# PREDETERMINATION SETTLEMENT AGREEMENT

CP# 08-17-70866  
HUD# 07-17-7447-8

#### **JACKSON CROSSING, LLC**

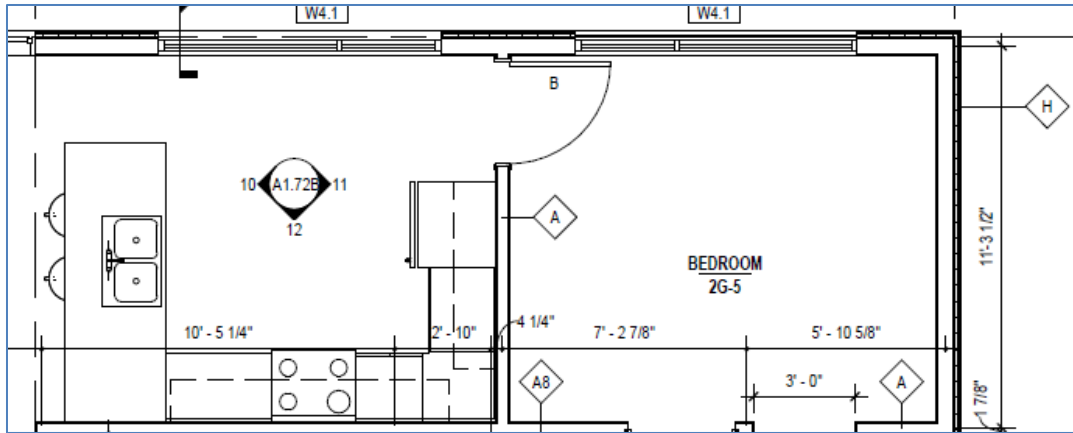
6) Except for Unit C416, the height of the top control buttons of the thermostats in all inspected units exceeded the 48"-maximum height, with measured heights ranging from 48 1/2" to 49 3/4".<sup>15</sup>

The heights of the thermostats in these inspected units would have been compliant with the 48"-maximum height requirement as referenced above if installed according to the plans. But, as built, they are too high, rendering them unusable by persons using wheelchairs.

6) Estes Construction will lower the thermostats so that the height of the top control buttons of the thermostats in all units do not exceed the 48"-maximum height, within 90 days of the date an agreement is executed by the parties.

6) ICRC concurs with Respondents’ proposal to lower the thermostats such that the height of the top control buttons of the thermostats in all units do not exceed the 48”-maximum height, within 90 days of the date of the Closing Letter from ICRC.

**UNIT C202 [3B]**

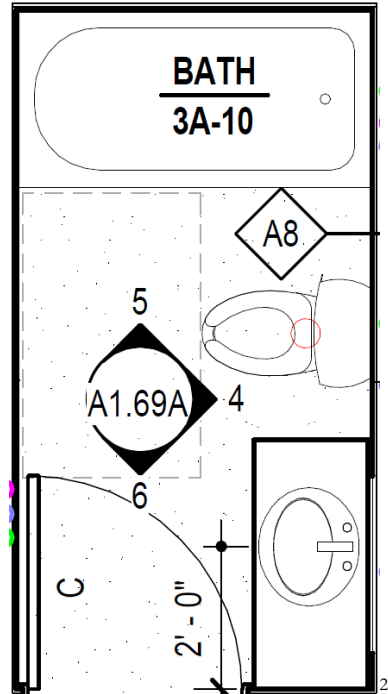
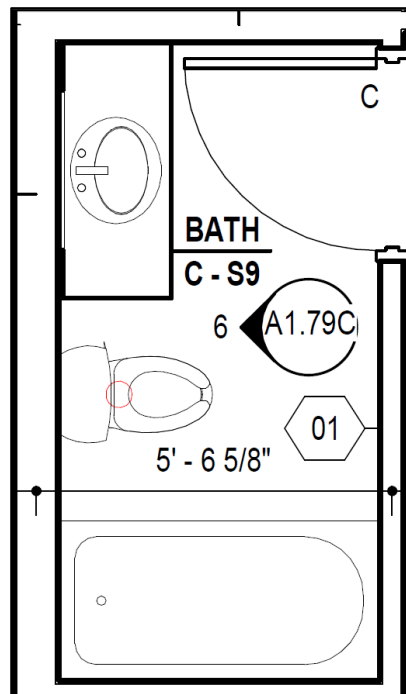
Based on the scaled drawing above for Unit C202, the clear floor space outside the swing of the door in the “CS-9” bathroom was designed to be about 30” by 51”, with the 30” side of the clear floor space being parallel and flush to the bathtub. Based on the scaled drawing for Unit A212, the clear floor space outside the swing of door in the “3A-10” bathroom at Unit A212 was designed to be about 30” by 48”.

The drop cloth was placed with the 30” side flushed against the bathtub in Unit C202. However, in Unit A212, the drop cloth could not be placed on the floor with the 30” side flushed against the bathtub because the toilet bowl overlapped the 48” side of the drop cloth by  $\frac{5}{8}$ ”, as measured by ICRC investigators.<sup>22</sup> As the drop cloth represents the clear floor space required by someone using a standard-size wheelchair, it could only be placed at a location free of encroachment by any of the bathroom fixtures upon this clear floor space. As reported in the next paragraph, the limitation of where the drop cloth could be placed in the bathroom at Unit A212 led to the significantly higher value of the measured distance for overlap of the door on the drop cloth.

In Unit C202, the opened door was found to overlap the 30”-by-48” drop cloth by  $7\frac{1}{4}$ ”, while in Unit A212, the door was found to overlap the drop cloth by  $25\frac{1}{2}$ ”.<sup>23</sup> This means that the clear floor space outside the swing of the door in bathrooms for both units is less than 30”-by-48”.

The clear floor space outside the swing of door in the bathrooms at both units would have been compliant with the 30”-by-48”- minimum clear floor space requirement referenced above if these bathrooms had been built according to the plans. But, as built, the clear floor space outside the swing of door is insufficient, rendering both bathrooms unusable by persons using wheelchairs.

- 8) Estes Construction will reverse the swing of the door at the bathroom in Units C102, C202, C302 and C402, to allow the bathroom door to swing out into the bedroom and result in the required clear floor space in the bathroom outside the swing of the door, within 90 days of the date an agreement is executed by the parties.

- 8) ICRC concurs with Respondents' proposal to reverse the swing of the door at the bathroom in Units C102, C202, C302 and C402, to allow the bathroom door to swing out into the bedroom and result in the require clear floor space in the bathroom outside the swing of the door, within 90 days of the date of the Closing Letter from ICRC.

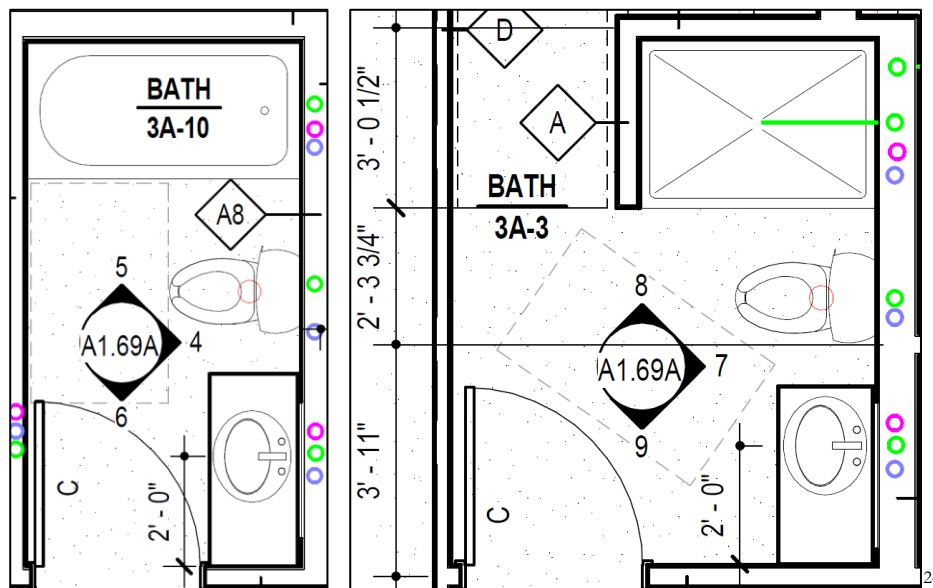
Based on the scaled drawings above, the clear floor space immediately adjacent to the bathing facility (1) in Bathroom “3A-10” was designed to have a clear floor space area measuring 30” by 48”, with the 30” side of the clear floor space being parallel and flush to the bathtub; and (2) in Bathroom “3A-3”, same clear floor space was designed to be 24” by 48”. As reported in the last section, ICRC Investigators measured the distance *from* the edge of the toilet bowl that extends out the furthest from the toilet fixture itself *to* the opposing wall at 29 <sup>3</sup>/<sub>8</sub>”, which prevents persons using a wheelchair from approaching the bathtub due to the width of the path being less than the 30”-minimum width for a stationary wheelchair and less than the 32”-minimum for a moving wheelchair.

The clear floor space at the bathing facility in Bathroom “3A-10” would have been compliant with the 30”-by-48”- minimum clear floor space required at the bathing facility if the bathroom had been built according to the plans. But, as built, the clear floor space at the bathing facility is insufficient in Bathroom “3A-10”. Additionally, as designed and built, Bathroom “3A-3” has insufficient clear floor space at the bathing facility. Therefore, both bathrooms in Unit A212 are unusable by persons using wheelchairs.

- 9) Invision will replace the toilets in the “C-S9” shared bathrooms in Units A212, A312, and A412 with a new toilet with a non-elongated bowl type toilet – which will protrude approximately 2 ½” less into the bathroom space – to allow for the required clearance of a 30”-by-48” clear floor space outside of the swing of the door, within 90 days of the date an agreement is executed by the parties.<sup>33</sup>

- 9) ICRC concurs with Respondents' proposal to replace the toilets in the "C-S9" shared bathrooms in Units A212, A312, and A412 with a new toilet with a non-elongated bowl type toilet – which will protrude approximately 2 1/2" less into the bathroom space – to allow for the required clearance of a 30"-by-48" clear floor space outside of the swing of the door, within 90 days of the date of the Closing Letter from ICRC.

**UNIT A212 [3A]**

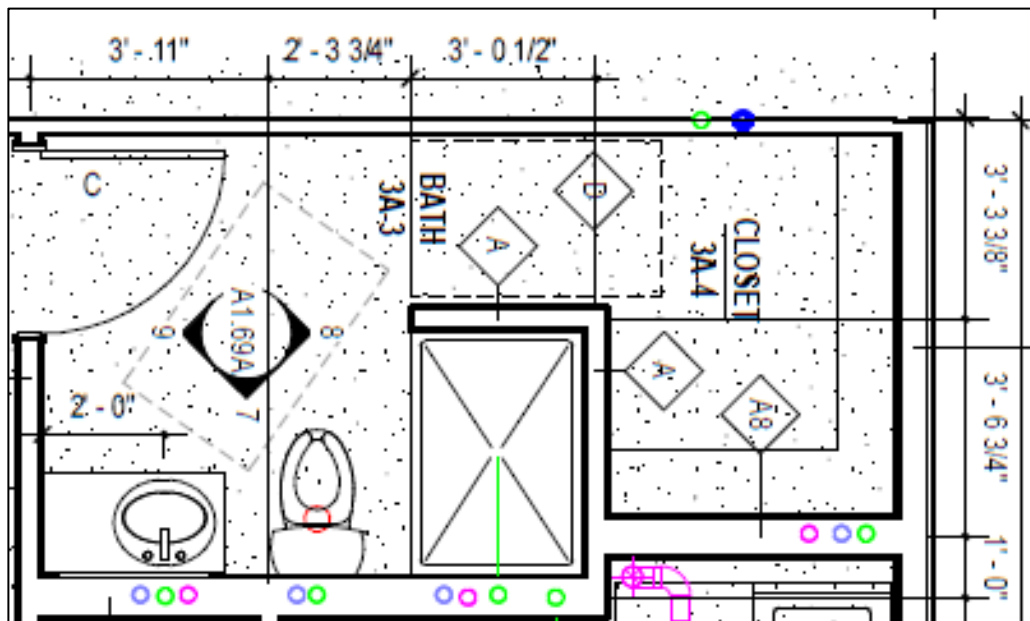
Based on the scaled drawings above, the route connecting the bathroom area with the walk-in closet in Unit A212 was designed to be about 39 1/2" long by 33 3/4" wide. ICRC Investigators measured this route at 39 5/16" long by 33 9/16" wide.<sup>26</sup>

The routes referenced above are too narrow because their measured width is less than 36" minimum required for routes that are longer than 24", which renders the routes in these bathrooms inaccessible for tenants who use wheelchairs.

- 10) Invision will remove or modify the shower and surrounding walls in Units A212, A312, and A412, so that the shower is entered from the South rather than from the East, and to increase the width of the passage to the adjacent closet to greater than 36” and provide 30”-by-48” of clear floor space at the shower.

- 10) ICRC concurs with Respondents' proposal (i) to remove or modify the shower and surrounding walls in Units A212, A312, and A412, so that the shower is entered from the South rather than from the East, and to increase the width of the passage to the adjacent closet to greater than 36" and provide 30"-by-48" of clear floor space at the shower; and (ii) to cut 1" to 2" off the wall to shorten the shelves present and will then re-install the drywall in that area and patch the floor finish as required in Units B416, B216, and B316. ICRC concurs with waiting until the units become vacant, but only as long as this retrofit is completed no later than one-year from the date of the Closing Letter from ICRC.

**UNIT B416 [1E]**

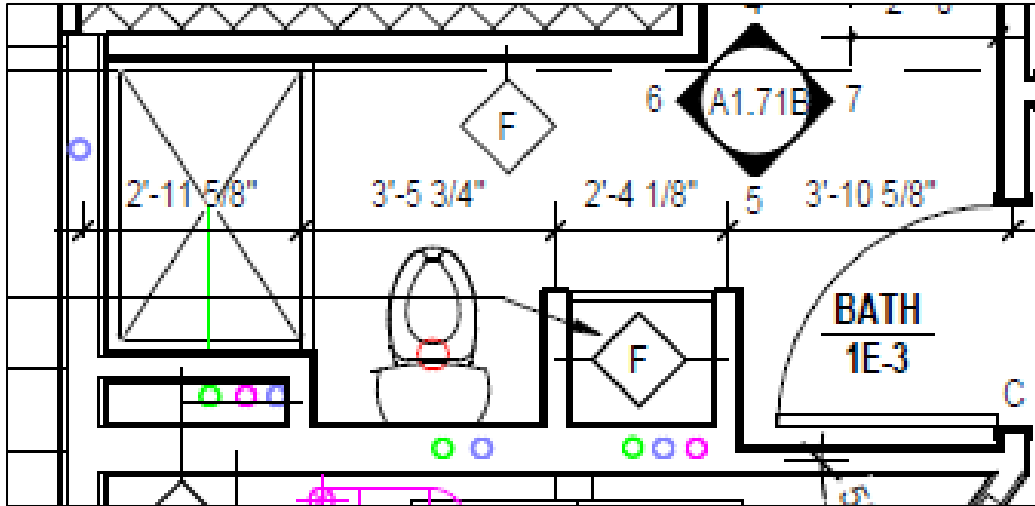
In Unit B416, the route from the area inside the bathroom entrance to the toilet was designed to be about 33 3/4" long by 36" wide. ICRC Investigators measured the length of this route at 36 1/8" long by 34 7/8" wide.<sup>27</sup>

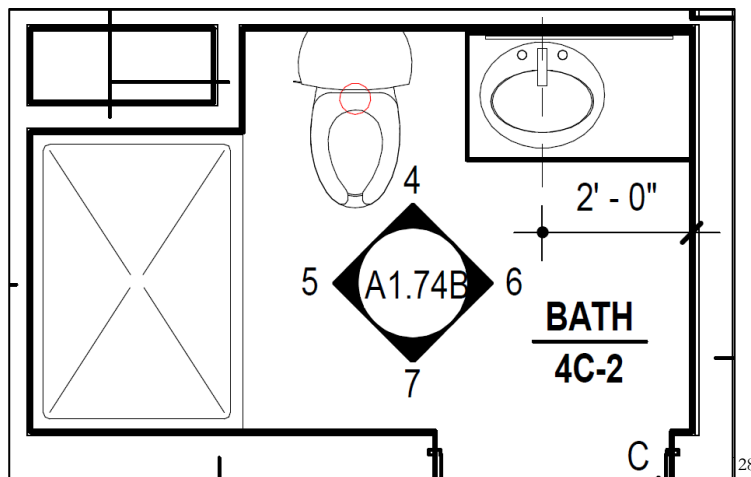
Based on the scaled drawing above, midline of the bathroom sink was designed to be 24” away from the wall. ICRC Investigators measured this distance at 18”, which is less than the 24”-minimum required by the Guidelines, when cabinets are not removable.<sup>29</sup> The base cabinets did not appear to be removable to ICRC Investigators, which was verified by Respondents during the inspection. This bathroom is unusable because the midline of the sink is too close to the wall to allow tenants using wheelchairs to make the required parallel approach.

- 11) Estes Construction will replace the countertop and move the midline of the sink 24” from the adjacent wall in unit B115, within 120 days of the date an agreement is executed by the parties.

- 11) ICRC concurs with Respondents' proposal to replace the countertop and move the midline of the sink 24" from the adjacent wall in unit B115, within 120 days of the date of the Closing Letter from ICRC.

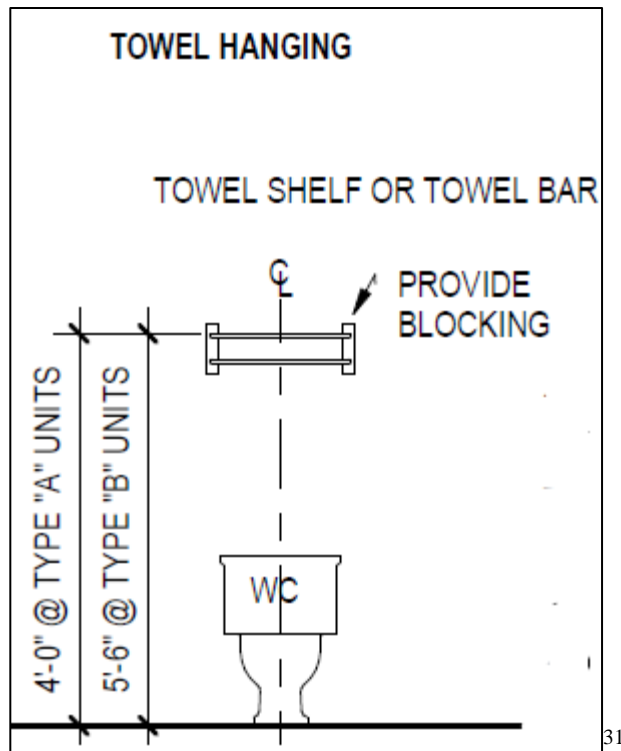
13) The plans submitted by Respondents included the following diagrams for the installation of the towel bars:

The height of the bathroom towel bars in in the Units A118, A413, A212, B400, A209, C110, C202, C212, C316, and C404 was measured at no less than 62” and were installed above toilets which have a depth of more than 30”. Therefore, the towel bars will need to be moved to a different wall at a height of no more than 54” if there are no obstructions because the depth of the toilet exceeds the maximum depth for obstructions.

The heights of the towel bars in these inspected units were not designed or built to be compliant with the maximum height requirements. As built, the towel bars are too high, rendering them unusable by persons using wheelchairs.<sup>32</sup>

- 13) Invision will install a towel hook in each unit at a height that will not exceed the permissible height, within 90 days of the date an agreement is executed by the parties.

- 13) ICRC concurs with Respondents' proposal to install a towel hook in each unit at a height that will not exceed the permissible height, within 90 days of the date of the Closing Letter from ICRC.
